MODEL MD900 SERIES
SERVICE LETTER PACKAGE

MODEL MD900[®] ROTORCRAFT (MD EXPLORER[®]) SERVICE LETTERS

Figure 1. Improved Rig Pin Access FOD Covers

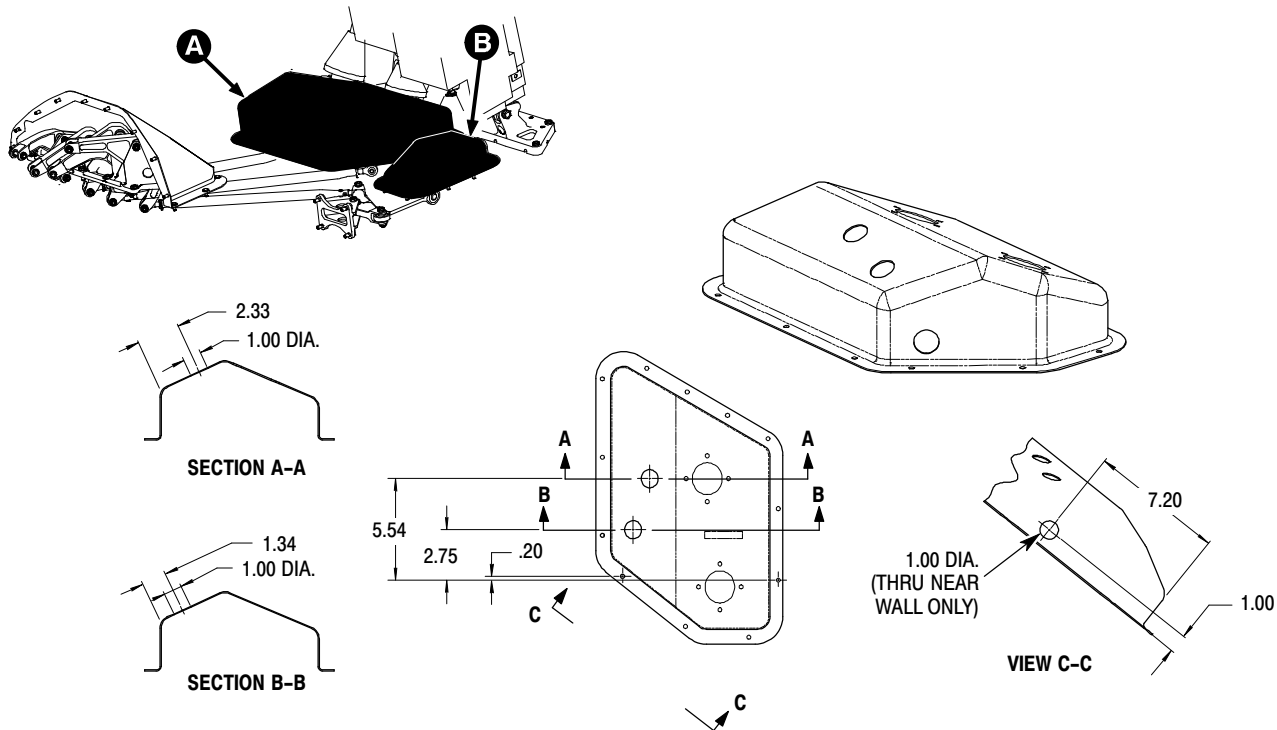
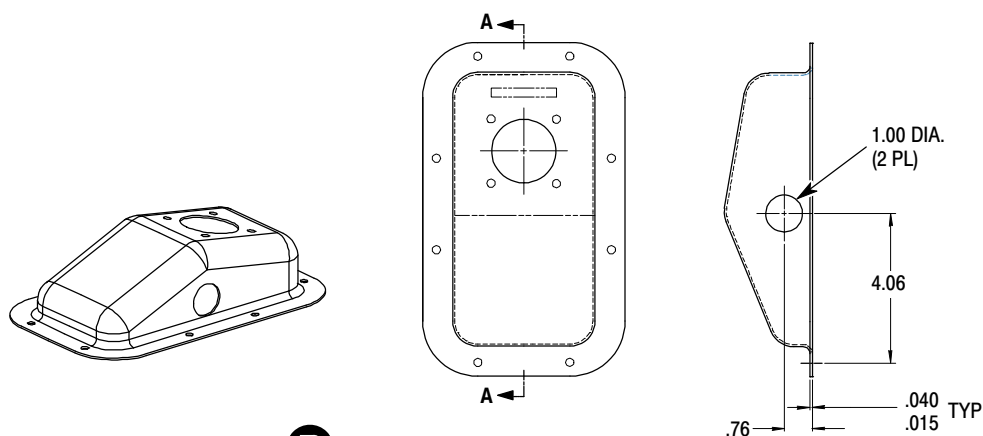
Holes can be installed in specific positions on the collective/longitudinal and lateral FOD covers to eliminate the need to remove the covers for flight controls rigging and rigging verification. Rig pin insertion can be done through the respective access holes.

Hole plugs are to be installed when the aircraft is not being serviced and during normal flight operations to prevent foreign objects or debris from entering the rig pin access holes. Plugs can be procured by contacting MDHS Parts Sales.

The part number for the hole plug is: 11394M (5 required).

Figure 1. Pedal Return Springs Removal

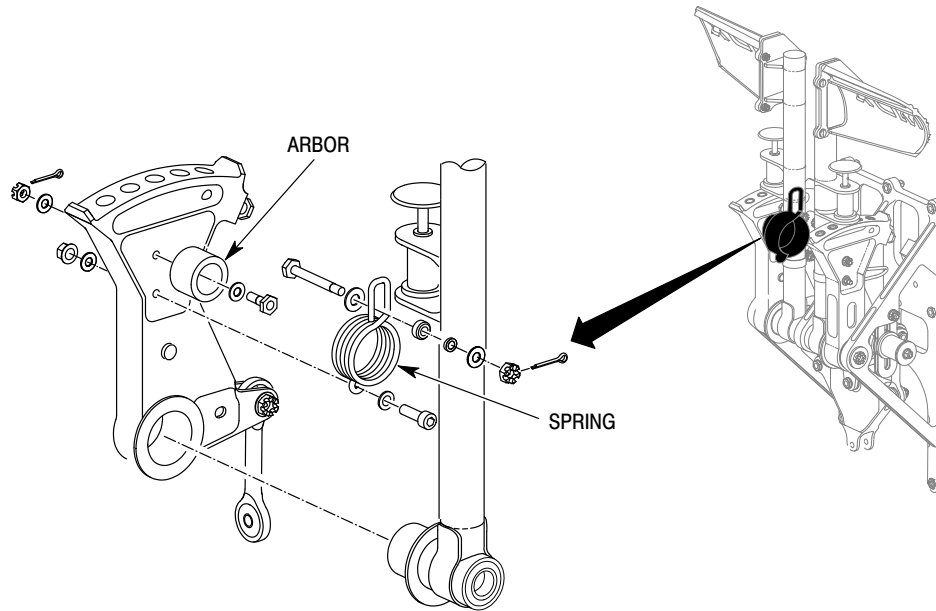
The purpose of this letter is to inform all MD900 helicopter owners and operators to remove the directional pedal return springs at their option.

Owners and operators may continue to operate the aircraft with the return springs installed or, may remove the springs, arbors and attaching hardware at any time during normal maintenance practices.

If the springs are removed, the existing pedal assemblies should be re-identified as a 900C6012007 modified part using contrasting ink or paint.

Figure 1. Door Latching Mechanism Removal

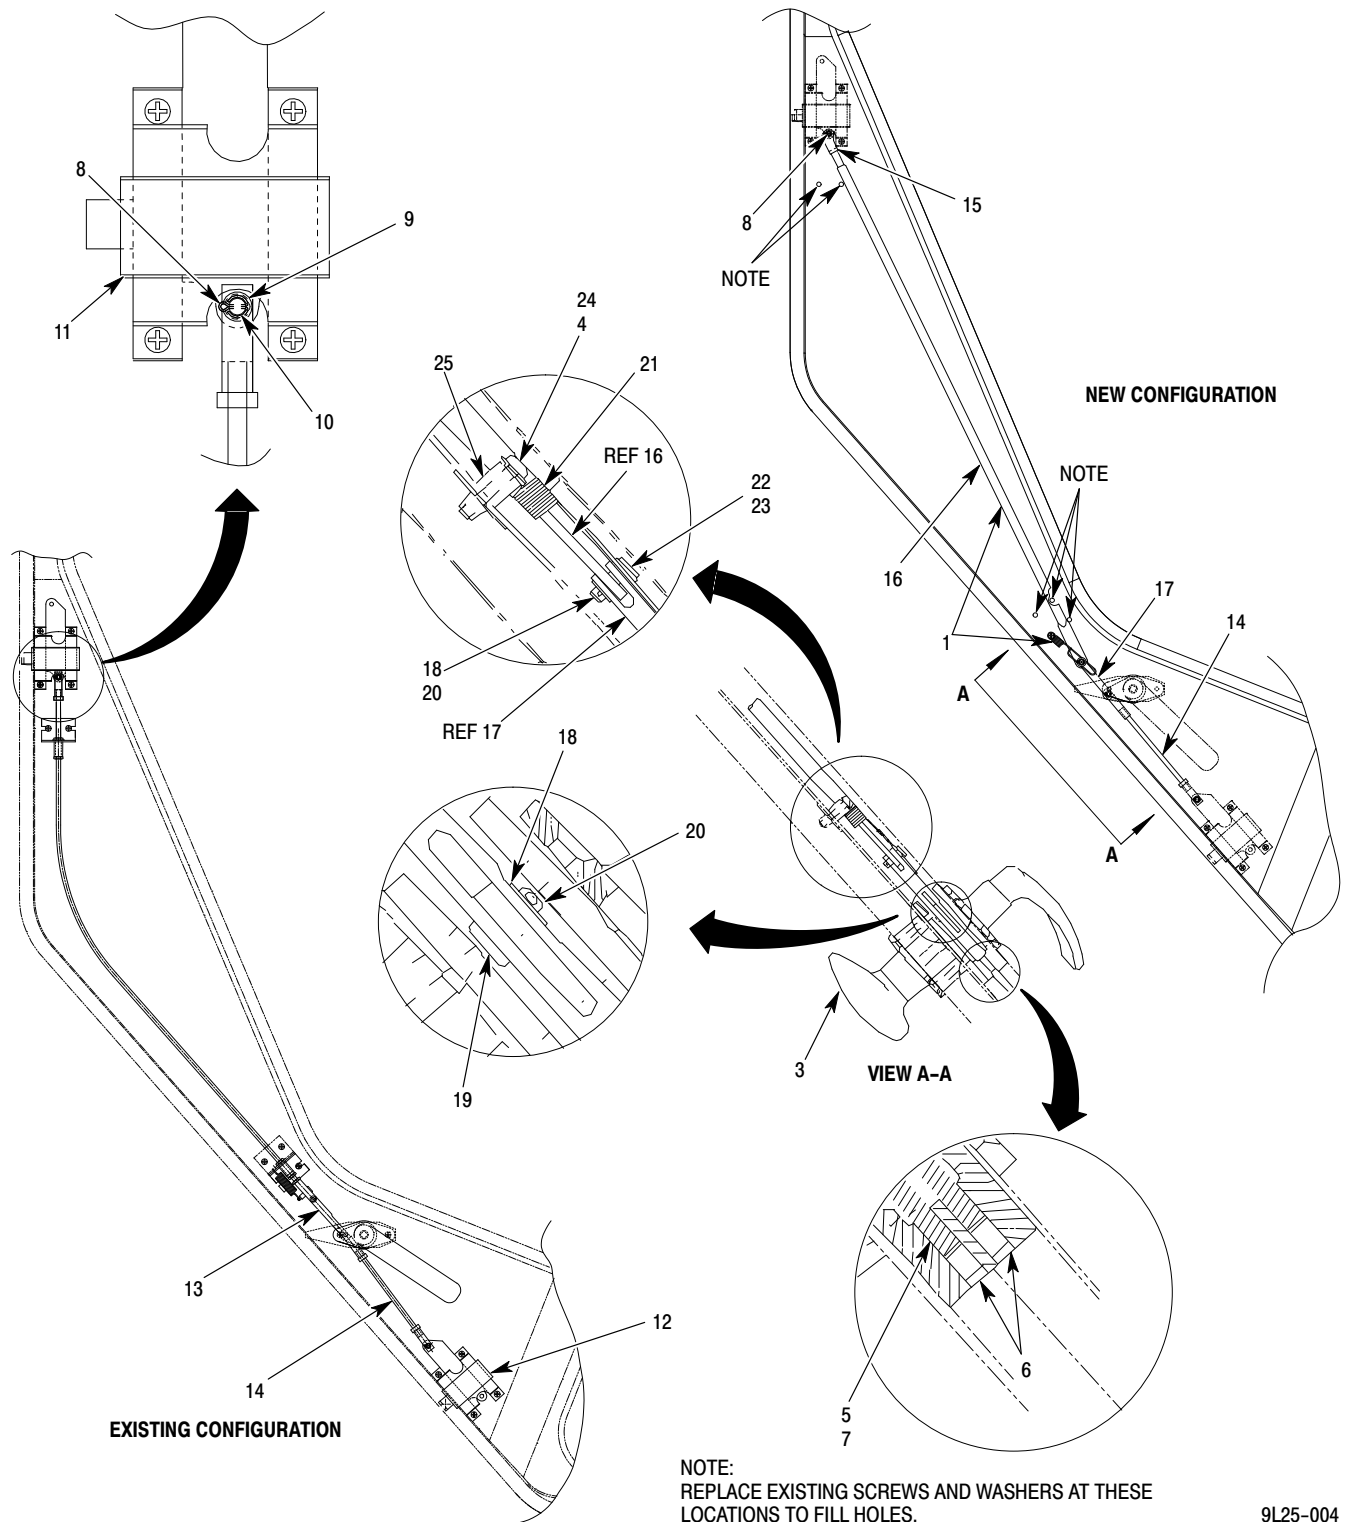
- C. Description: Procedures in this Letter provide operators with instructions to modify the existing Cockpit Door Latching Mechanism, P/N 900F3305181-101/-102 to the upgraded configuration, P/N 900F3305187-101/-102 .

- A.** Remove screws that attach entire latching mechanism (1) to door structure (including screws from outside door handle assembly (3)).

- B.** Remove compression springs (5) from door handle (3) by releasing screws (6).
- C.** Replace springs (5) with replacement compression springs (7) and secure with existing screws (6).
- D.** From upper latch block assembly (11), remove and discard cotter pin (8). Remove and retain washer (9) and clevis pin (10).
- E.** Except for that of the lower latch block assembly (12), remove and discard remainder of cotter pins (8).
- F.** Remove and retain remainder of washers (9) and clevis pins (10).
- G.** Remove link (13) from upper end of lower push/pull rod (14).
- H.** Install clevis (15) onto connecting tube (16).
- I.** Attach to upper latch block (11) using washer (9) and clevis pin (10). Install new cotter pin (8).
- J.** Install LH clevis (17) onto upper end of lower push/pull rod (14).

- K.** Attach to door handle assembly (3) using washer (18) and clevis pin (19). Install new cotter pin (20).
- L.** Attach clevis (17) to connecting tube (16) and extension spring (21) using clevis pin (22) and washers (18 and 23). Install new cotter pin (20).
- M.** Re-install modified latching mechanism (1) to door structure using original screws.
- N.** Secure extension spring (21) to door structure in remaining unused hole using screw (24), spacer (25) and washer (4).

Figure 1. Pedal Friction Hardware Change.

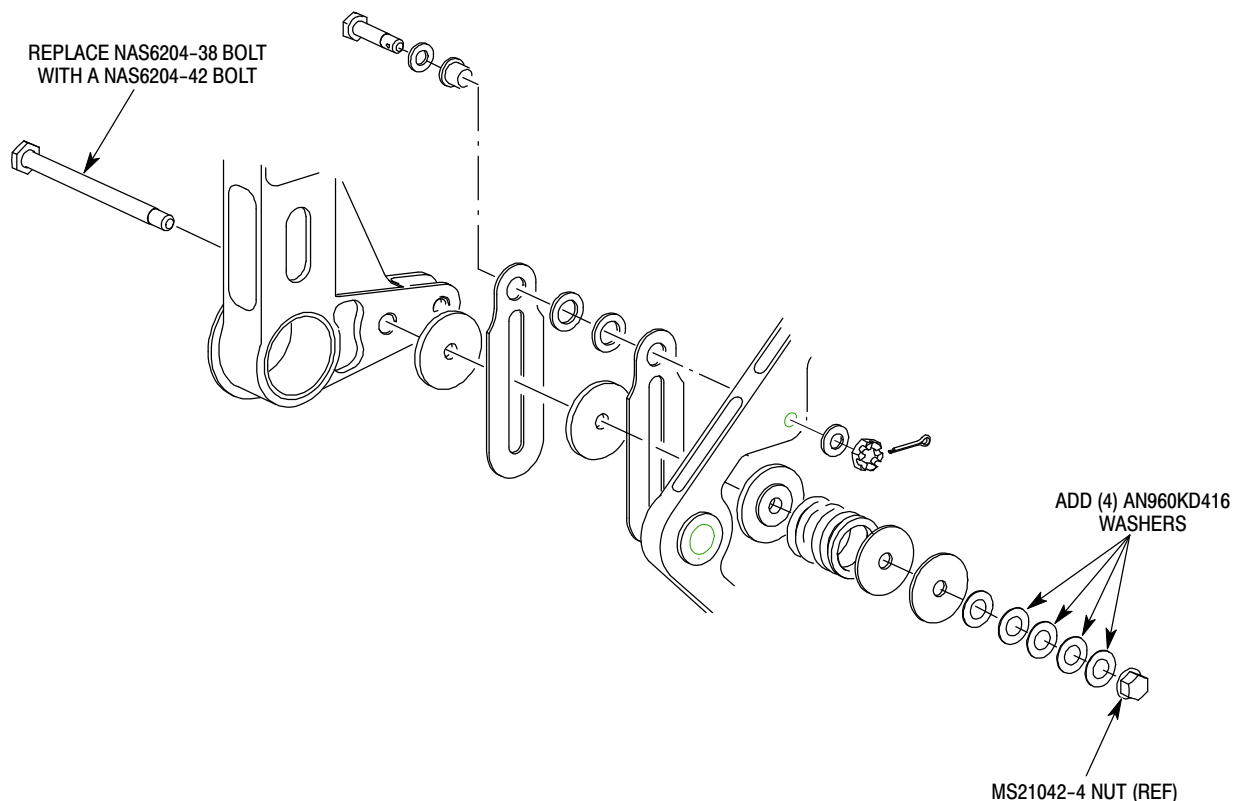
Operators are now allowed to make a change to MD900 pedal assembly hardware that will allow pedal breakout forces to be maintained by providing additional adjustment capability. The NAS6204-38 bolt may be replaced with a NAS6204-42 bolt. Additionally, four AN960KD416 washers must be added under the MS21042-4 nut as shown in Figure 1. Removal of any number of AN960KD416 washers is acceptable to achieve required breakout forces.

Figure 1. Inspection Hole location

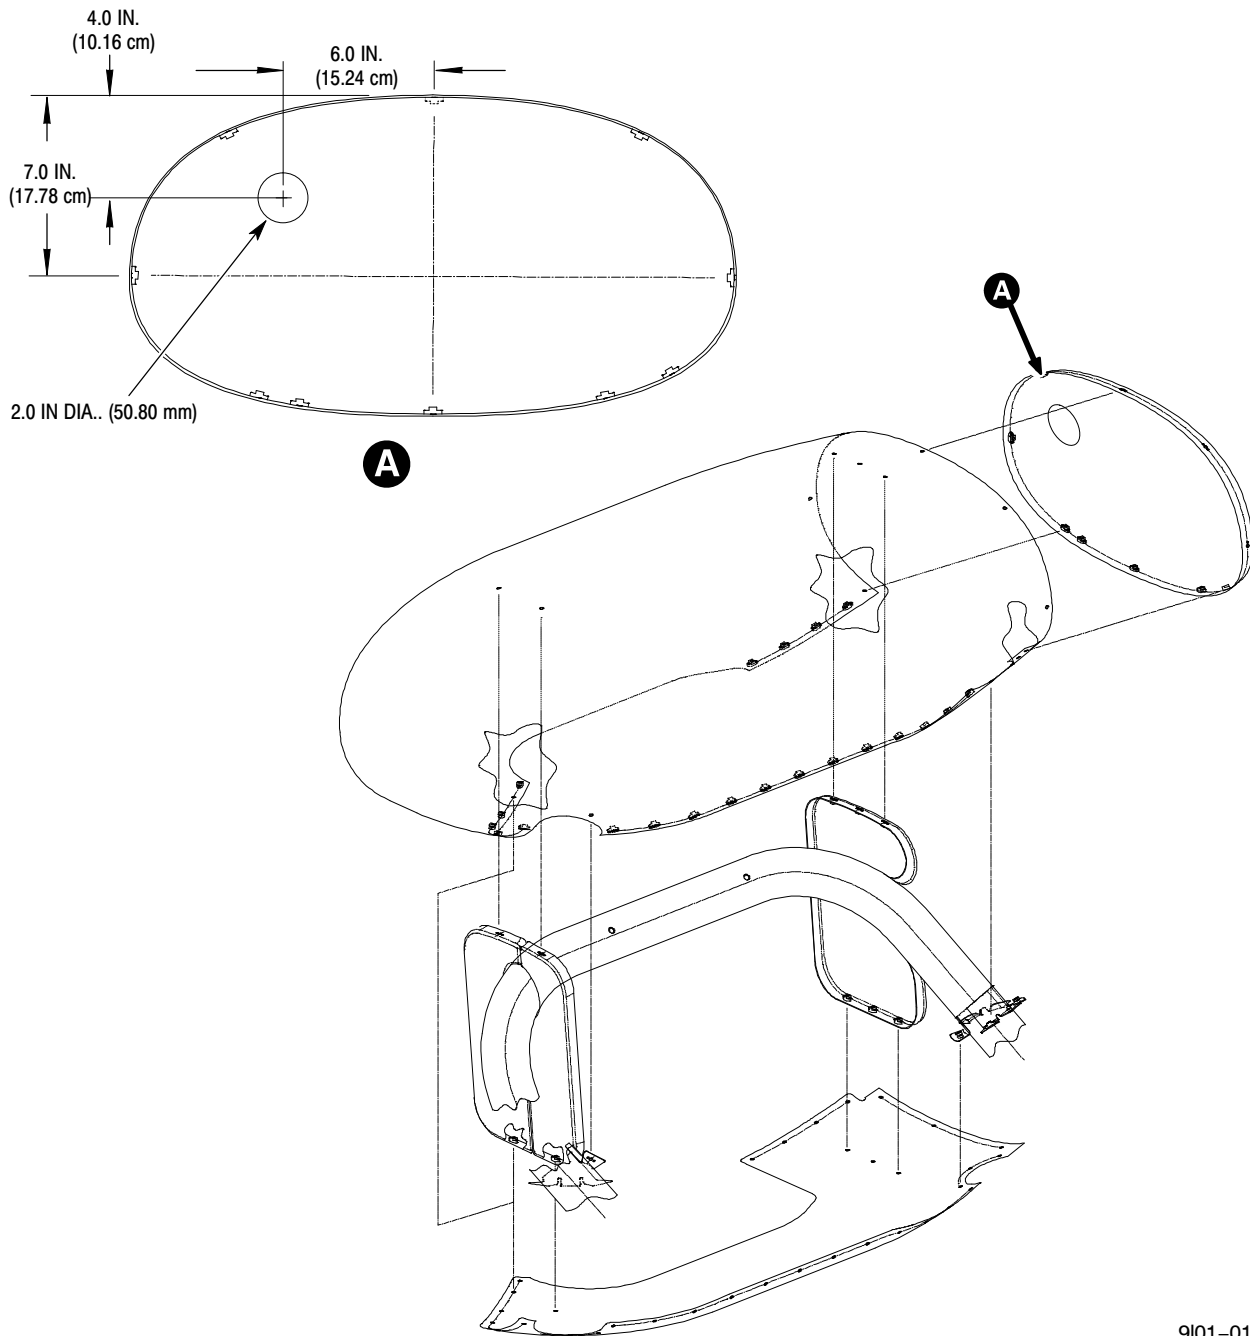
- DESCRIPTION:** This Letter provides operators with instructions to modify their hoist fairing to provide access for inspection.

- Locate hole as shown in Figure 1.

- Pilot hole with a high speed drill to match hole saw pilot size.
- Cut hole to size with a 2 inch diamond tipped hole saw.
- Smooth edge with 280 grit sandpaper or finer.

- Seal edge of hole with primer and topcoat.

Figure 1. Seat Modification for 4 Point Restraint System

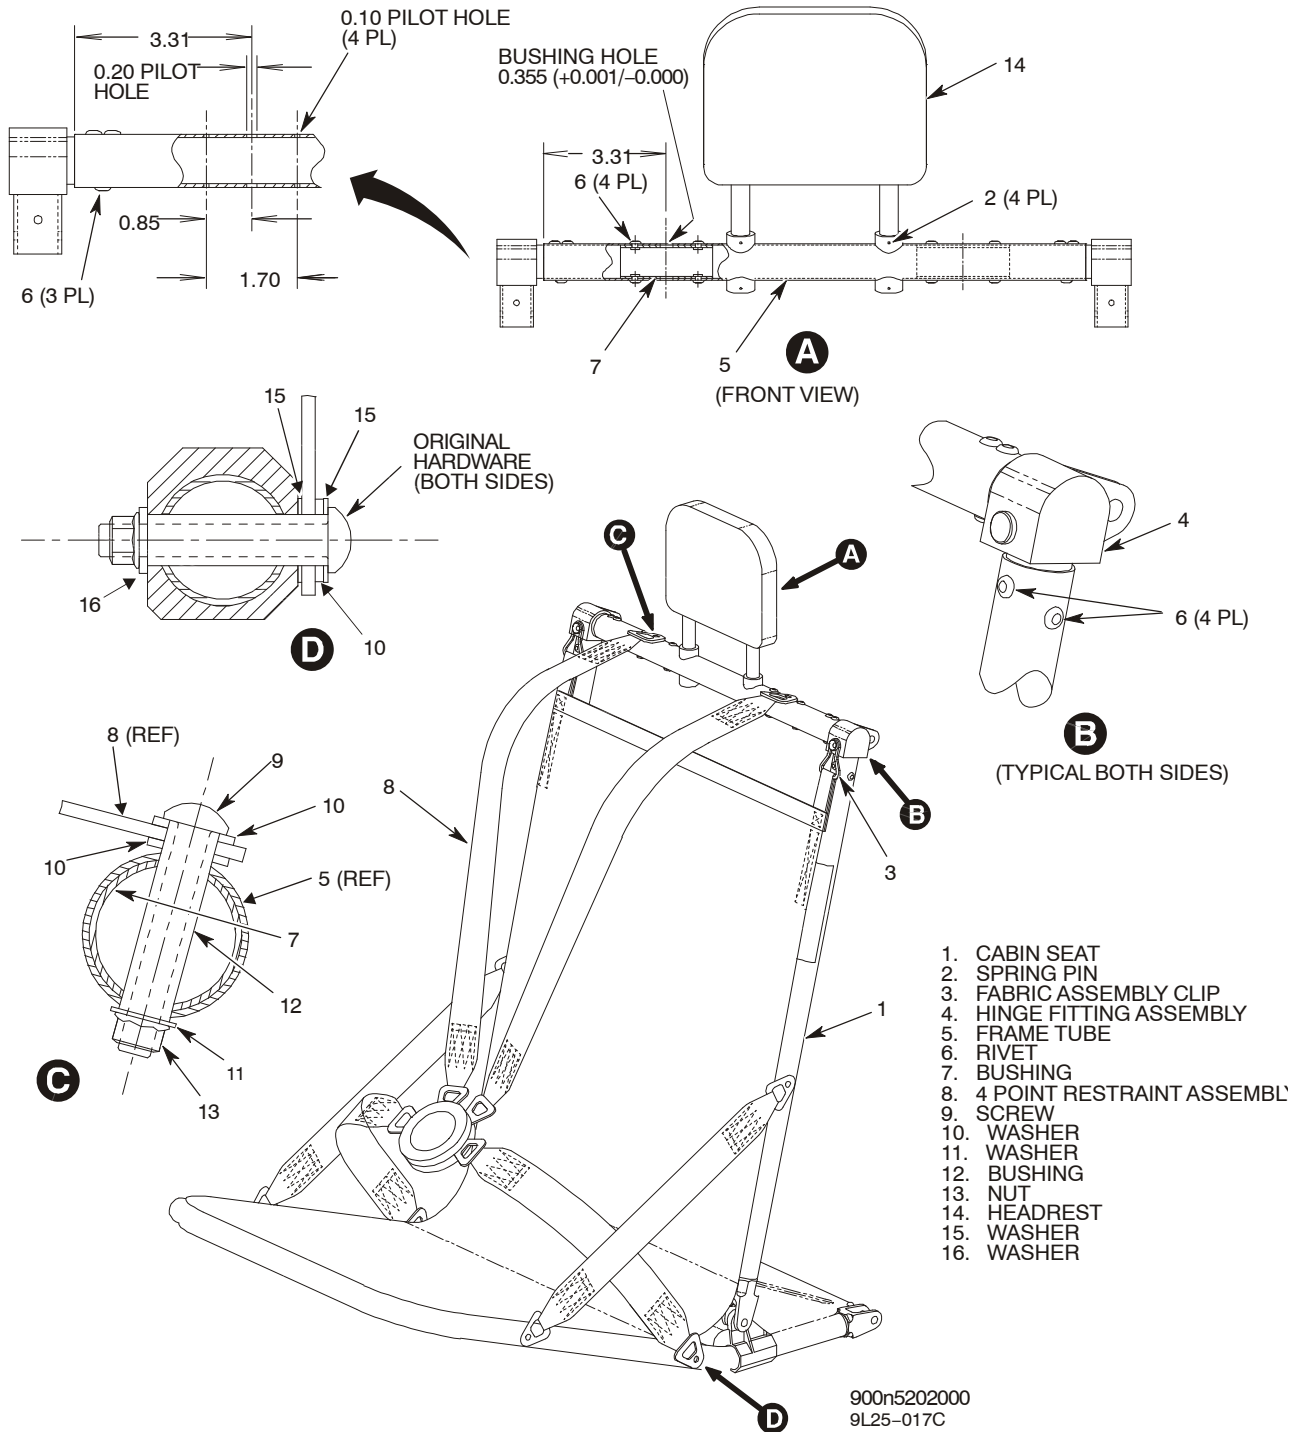
*MDHI has certified an upgraded 4 point cabin seat restraint system as a replacement to the 3 point system. The 900N3202141-101, -103, and -105 cabin seat can be changed to accept the new 4 point restraint. The four point restraint can be installed on the 900N3202141-107 cabin seat without change. New 4 point restraints (4-01-225501, 4-01-115501) are to be procured directly from the manufacturer, refer to Replacement Parts/Supplies.

- (1). Remove cabin seat (1) (Ref. CSP-900RMM-2, Section 25-20-00).
- (2). Remove 3 point restraint from seat (1). Keep removed hardware for installation of 4 point restraint.
- (3). Modify the 900N3202141-101, -103, -105 and -107 cabin seat as follows:
 - (a). Disconnect fabric clips (3) from hinge fitting (4).

- (b). Remove rivets (6) from fittings (4).
- (c). Remove frame tube (5).
- (d). Remove rivets (6) from fitting (4) on right side of frame tube (5).
- (e). Remove fitting (4) on right side of frame tube (5).

- (p). Install rivets (6). Install wet with epoxy primer.
- (q). Install fabric clips (3) on fittings (4).
- (r). If removed, install headrest (14). Use new spring pins (2).
- (4). Install new restraint (8) on seat frame.
- (a). Install Upper attachments hardware. Ref Figure 1 detail C
- (b). Install Lower attachments hardware. Ref Figure 1 detail D
- (c). Torque Nuts (Ref. CSP-SPM, Section 20-10-00)
- (5). Identify seat (1) as 900N5202000-103 adjacent to name plate.
- (6). Install cabin seat (Ref. CSP-900RMM-2, Section 25-20-00).

Figure 1. Baggage Door Window Installation

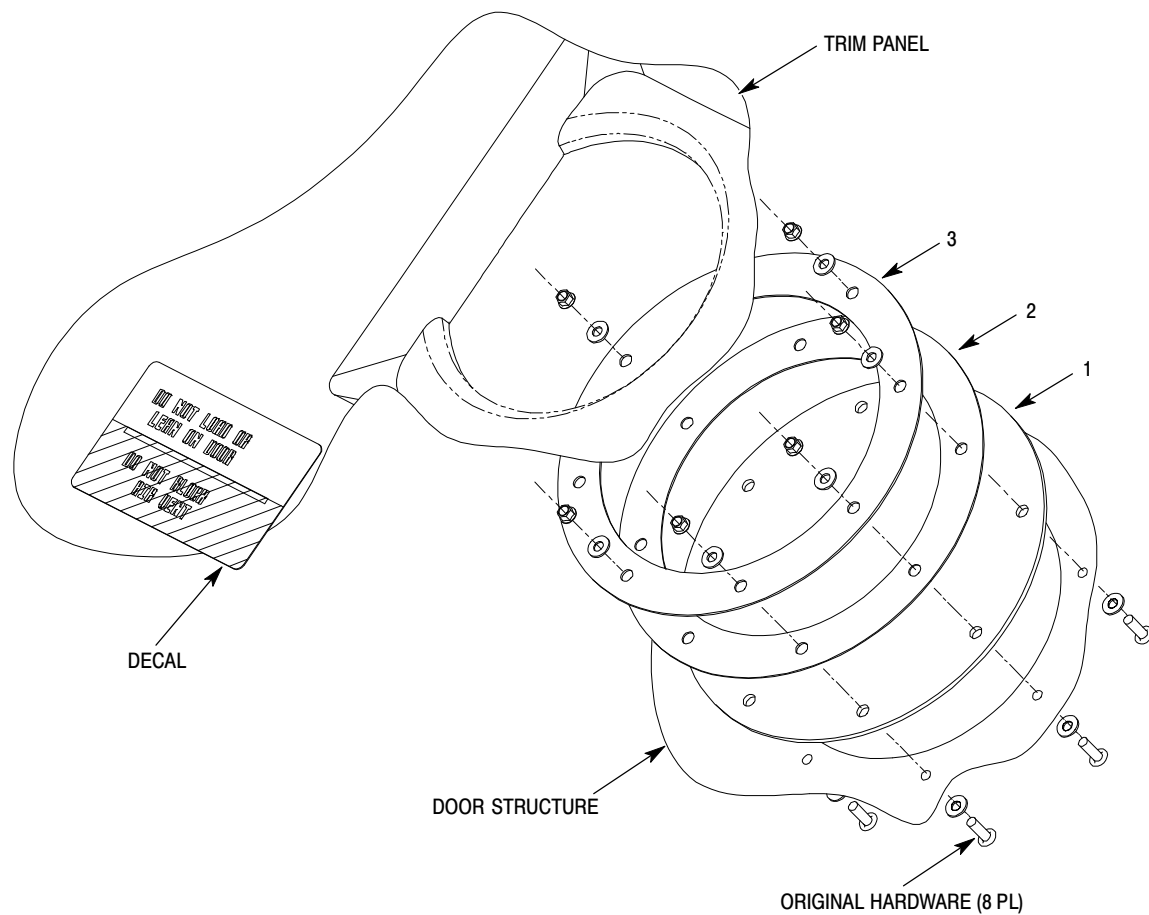
At the discretion of the owner/operator, the baggage door vent cover may be removed and replaced with transparent window material. Instructions in this Letter provide customers with details to modify the baggage door vent opening to eliminate airflow either in or out of the baggage area.

- A. Remove baggage door interior trim panel (Ref. CSP-900RMM-2, Section 25-50-00, Door Trim Panel Removal).
- B. Remove vent cover and retain original hardware for installation of window.
- C. Fabricate window, gasket and doubler per information in Figure 2.
- D. Install window (1), gasket (2) and doubler (3) onto door structure using original hardware per Figure 1.
- E. Install baggage door interior trim panel (Ref. CSP-900RMM-2, Section 25-50-00, Door Trim Panel Installation).
- F. Remove lower portion of existing decal, or paint over lower portion using flat black paint. Remaining decal should read: "Do Not Load Or Lean On Door."
